Groundwater Remedy Phase 1 Construction, PG&E Topock Compressor Station, Needles, California

Work Variance Request #3 – Proposed changes within the Construction Headquarters (CHQ) fence line

Revised Drawings for Work Variance Request #3

Drawings from Approved Final Design (November 2015)

TOPOCK GROUNDWATER REMEDIATION PROJECT
CONSTRUCTION HEADQUARTERS YARD PLAN
 GAS TRANSMISSION & DISTRIBUTION
 PACIFIC GAS AND ELECTRIC COMPANY
 SAN FRANCISCO, CALIFORNIA

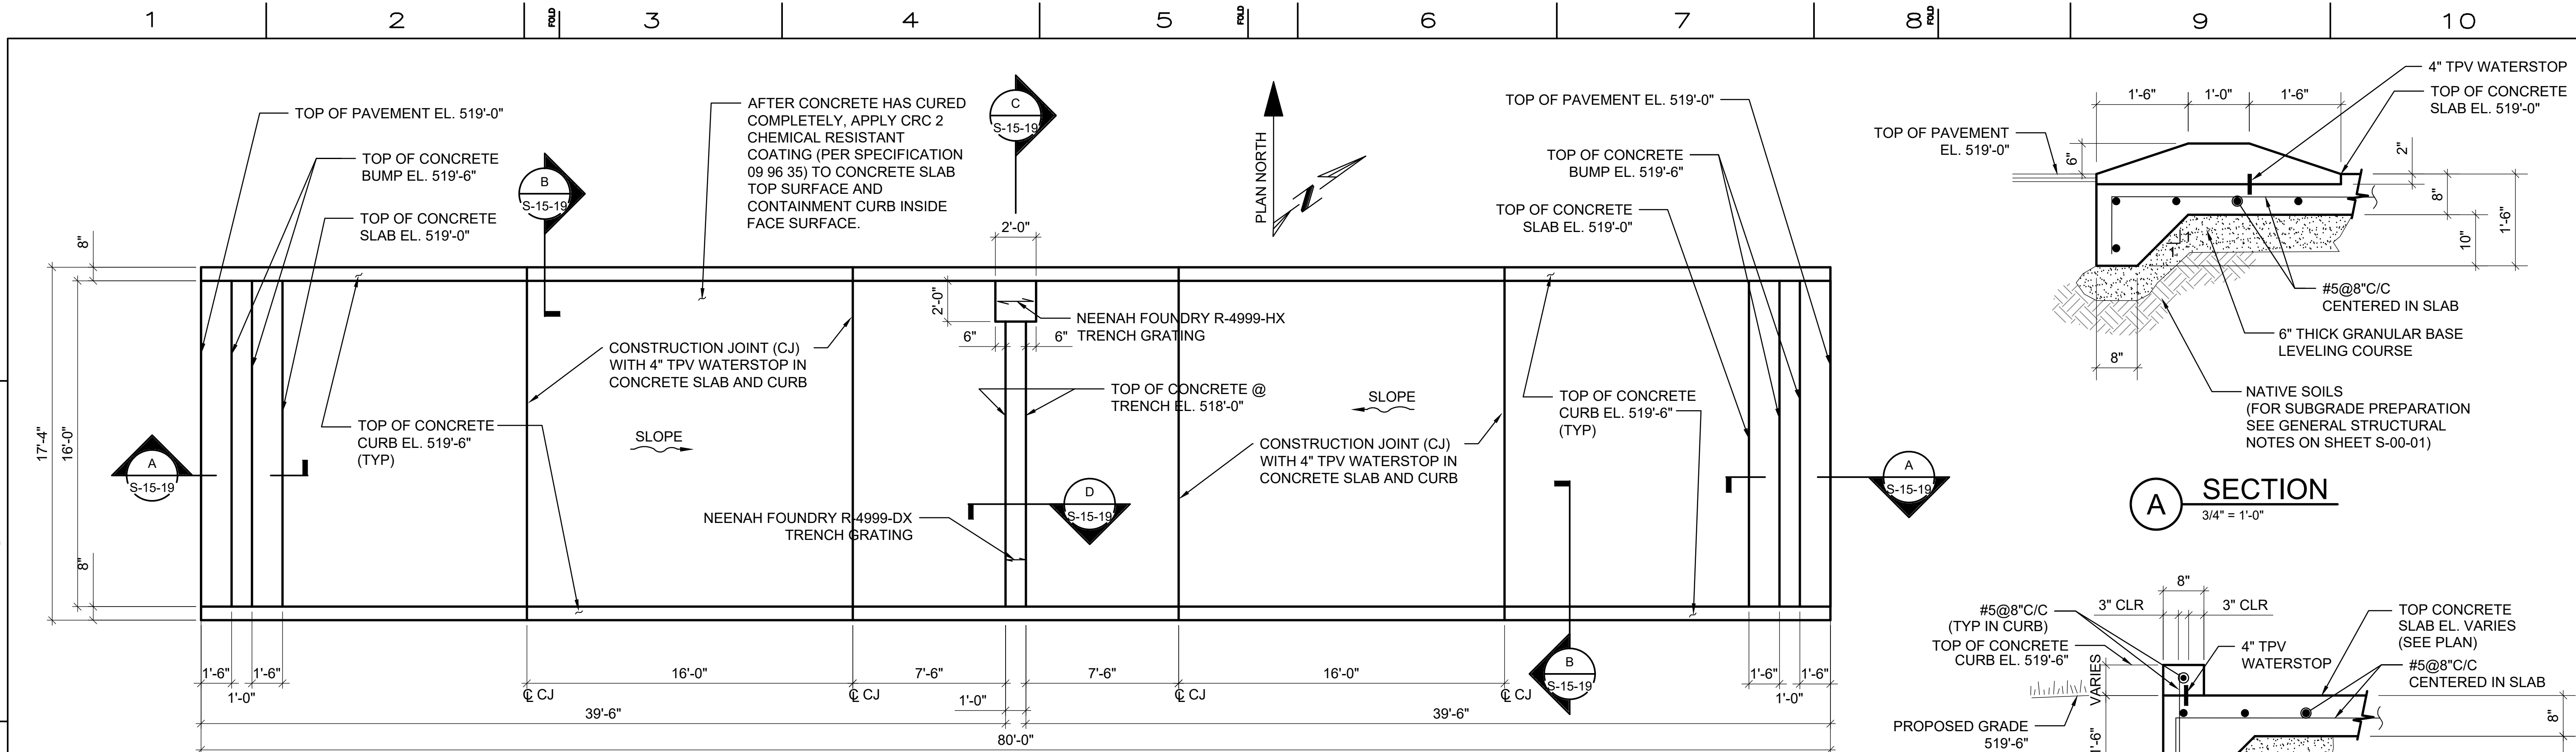
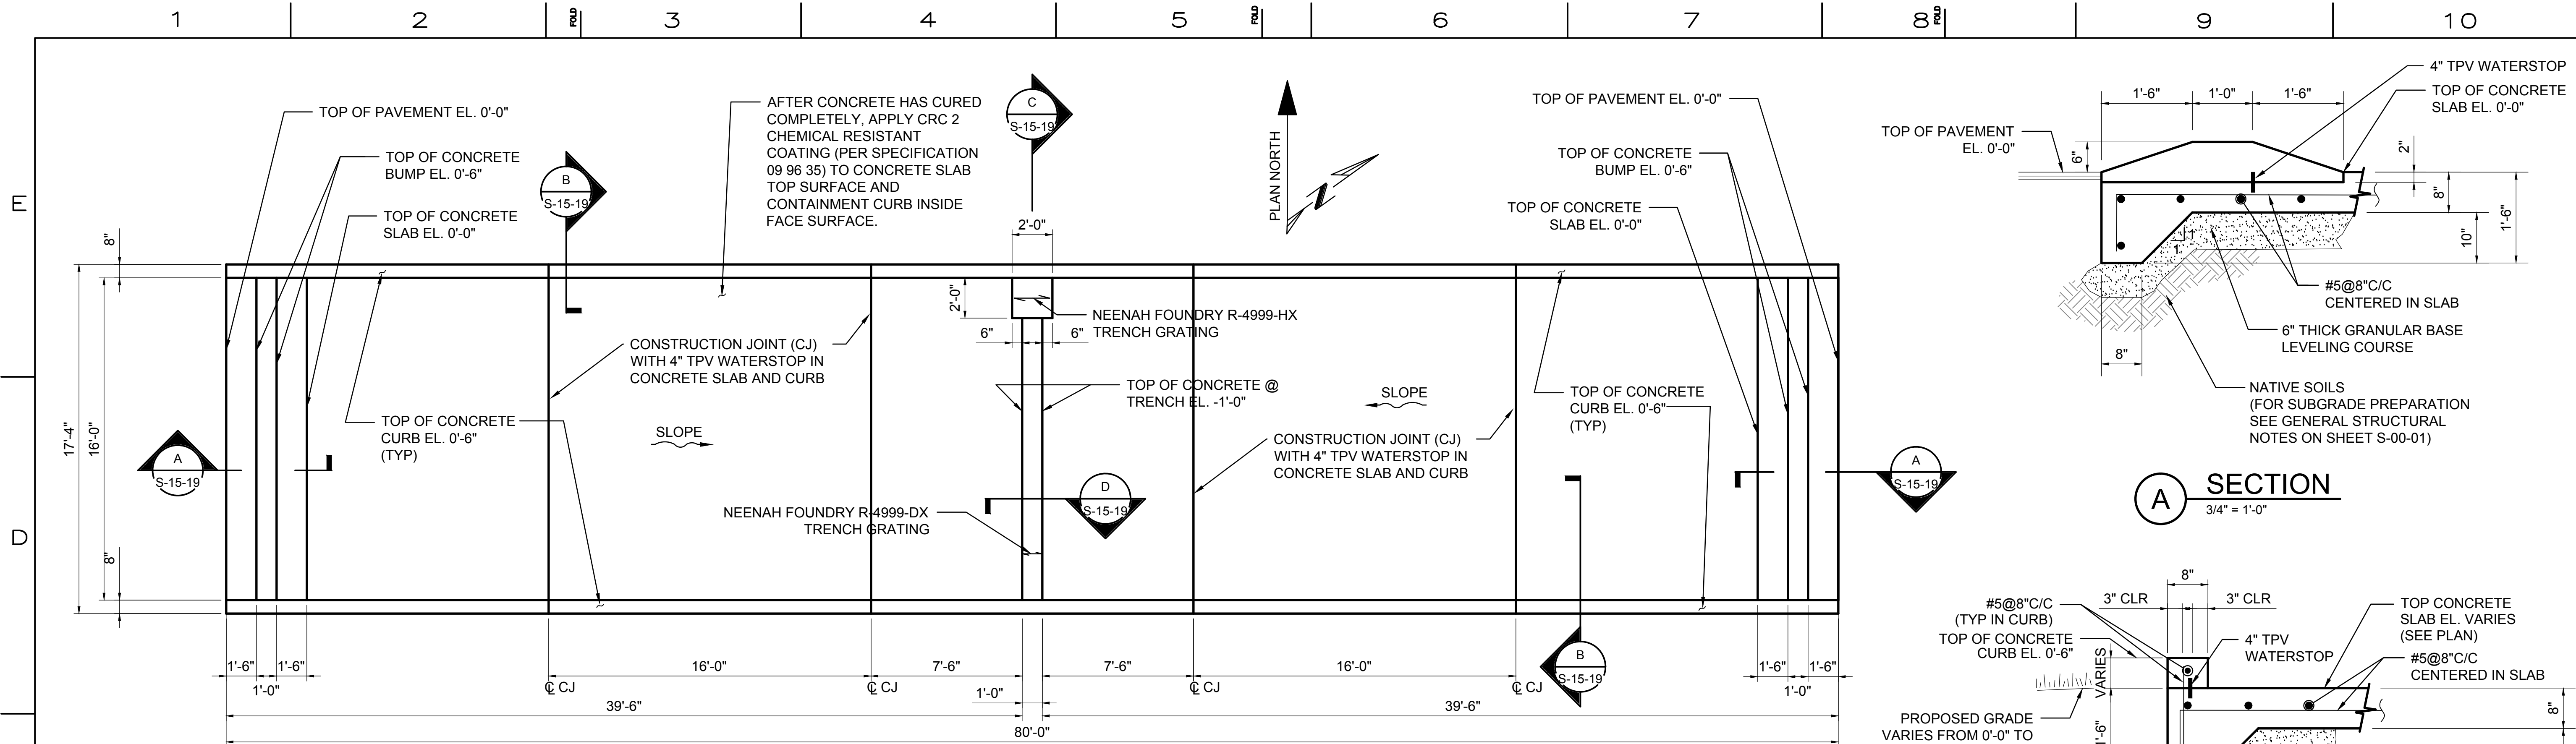
- a) **Relocate the decontamination pad from the western fence to the northern fence (near the western corner).**
Based on recent survey data collected during construction, the difference in ground elevation between northern and southern end of the pad is about 4 feet. Moving the pad to the northern fence would eliminate the difference in ground elevation and reduce the amount of soil disturbance by at least 80 cubic yards.

- d) **Swap the location of the construction trailers and the sunshade and change the configuration of the sunshade from a rectangle to a square.** This change will allow for more working space within the CHQ. All functions that would occur in the Workshop/Sampling Processing building will be conducted in the construction trailers.
